To: City of Mills
Attn: Casey Coates
Re: Wyoming Classical Academy Site Review
Location: 6389 Poison Spider Ln., Mills, WY 82604

Based on the review received dated 9/28/2026, the following changes have been made to the above-mentioned drawings. You will find an itemized list which addresses each comment individually. You will find the original comments followed by our response in bold.

Storm Water Drainage Study -Wyoming Classical Academy

TYPICAL CURB CUT DETAIL
NOT TO SCALE

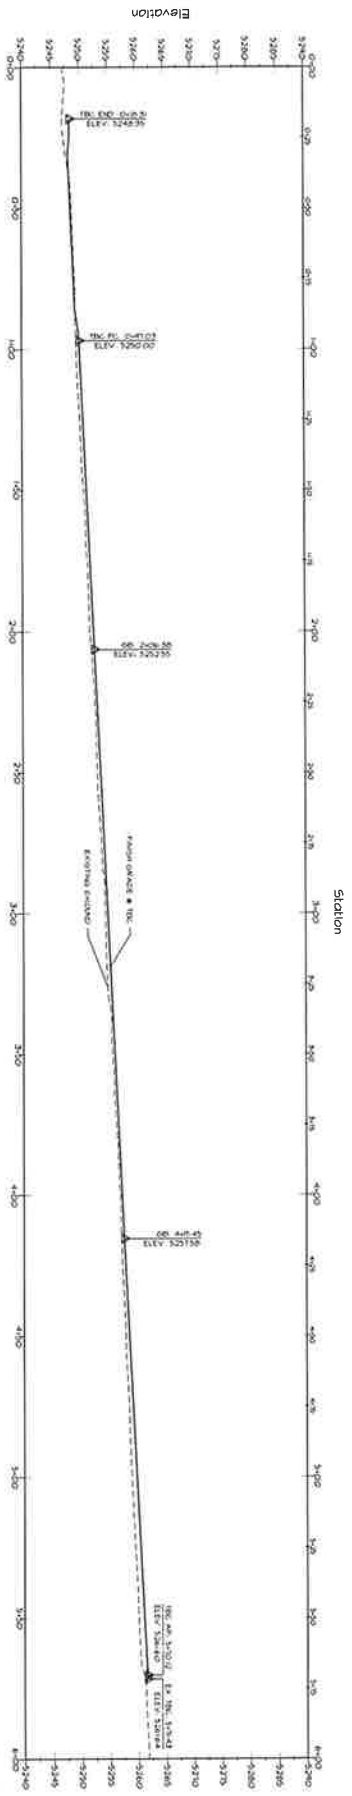
3. Show planting and irrigation for the 5-ft strip on C500. It is labeled only as "park strip", with no surface or plantings specified.

1. Show how gutter flow from the new curb and gutter on Poison Spider Lane will be conveyed to the ditch (curb cuts, inlets, or rundowns).

3 Response: Revised accordingly. Irrigation notes on the plans and design will be completed during the construction phase with the contractor.

1 Response: Runoff collected in the new Poison Spider curb and gutter will be conveyed to the existing drainage ditch by curb cuts allowing overland flow into the ditch. See new detail 2/C500.

FIRE HYDRANT ASSEMBLY
NOT TO SCALE

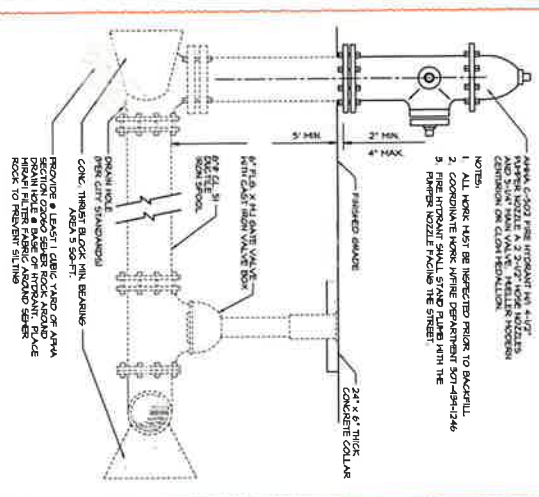
2. Mills Engineering Comment – C400/Upsize the C900 size to 8" to accommodate fire flows related to line length, remove the 45 bends, and install a 6" tee to the fire hydrant; blind flange the end of the 8" to accommodate future needs of the school from the 8".

2 Response: The C-900 fire line supplying the proposed fire hydrant has been upsized to 8-in. The 45 bends have been removed, and the utility sheets include a callout to install a tee at the hydrant with a blind flange on the west connection for future needs. See sheets C400 and C401.
